River Road Water Line Replacement
Rivet Blvd. to Willswood Lane
Project No. 2015-049-WR
Proposal No. 50-00117630

BID FOR: River Road Waterline Replacement – Phase 2
Willswood Lane to Rivet Blvd.
Public Works Project No. 2015-049-WR
Bid Proposal No. 50-00117630
(Owner to provide name of project and other identifying information)

BID PROPOSAL No. 50-00117630
 ADDENDUM No. 1

PROJECT NO.		514-01	
DATE		SEPTEMBER 2018	
SCALE		AS SHOWN	
SHEET NO.		4	
L.A. DEPARTMENT OF HEALTH & HOSPITALS RIVER ROAD WATER LINE REPLACEMENT RIVER BOULEVARD TO PACHA LINE SUMMARY OF ESTIMATED QUANTITIES

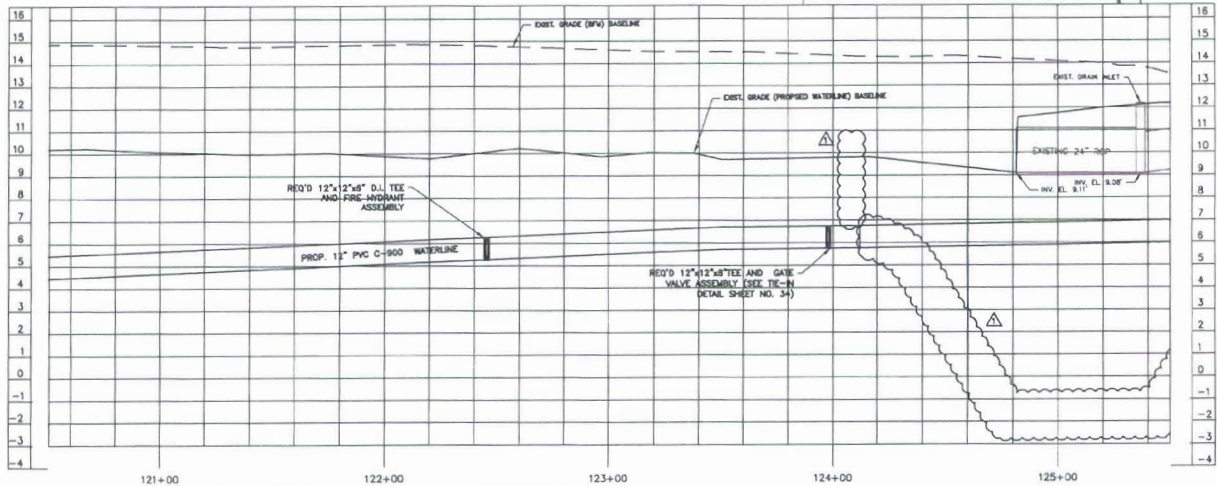
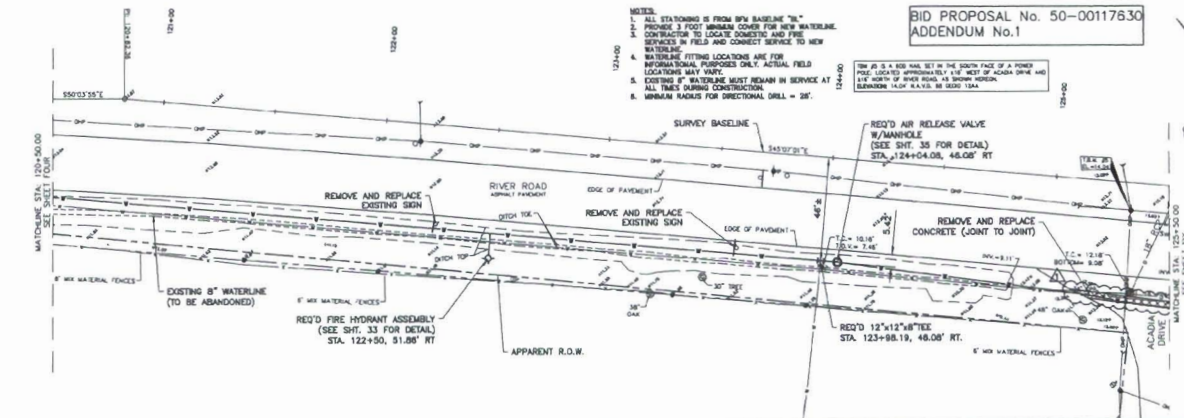
Sheet No. 4

Quantities have been updated and a new items added.

PROJECT NO. 514-81
DATE: SEPTEMBER 2016
SCALE
SHEET NO. 25

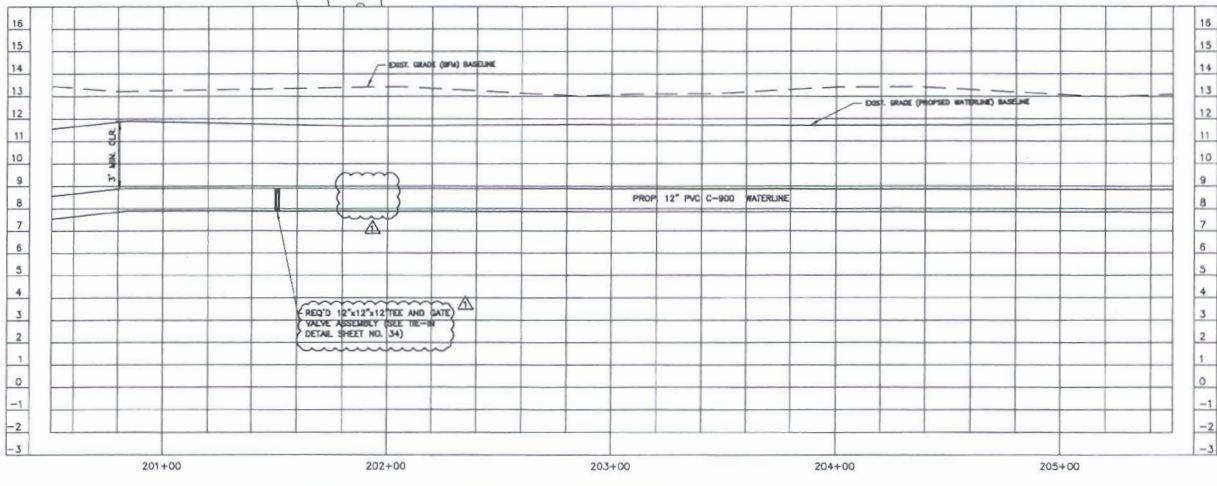
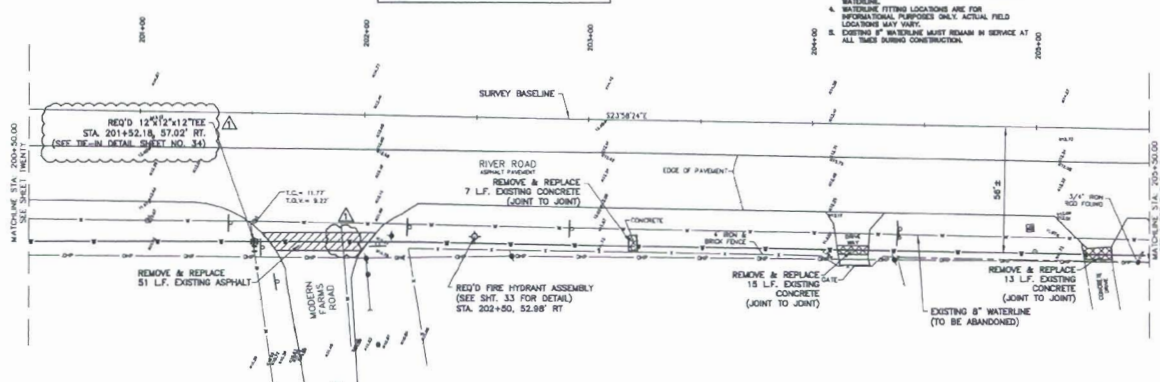
Sheet No. 25

Tie-in details at Modern Farms Rd. have been revised.

Answer 5: The size of the waterline at Sta. 201+52.18 is 12" in diameter. The type will have to be verified in the field by the contractor. A 12"x12"x12" tee will be required for this tie-in. The size of the waterline at Sta. 201+91.58 is 2" and will be paid as a water service connection up to 2".
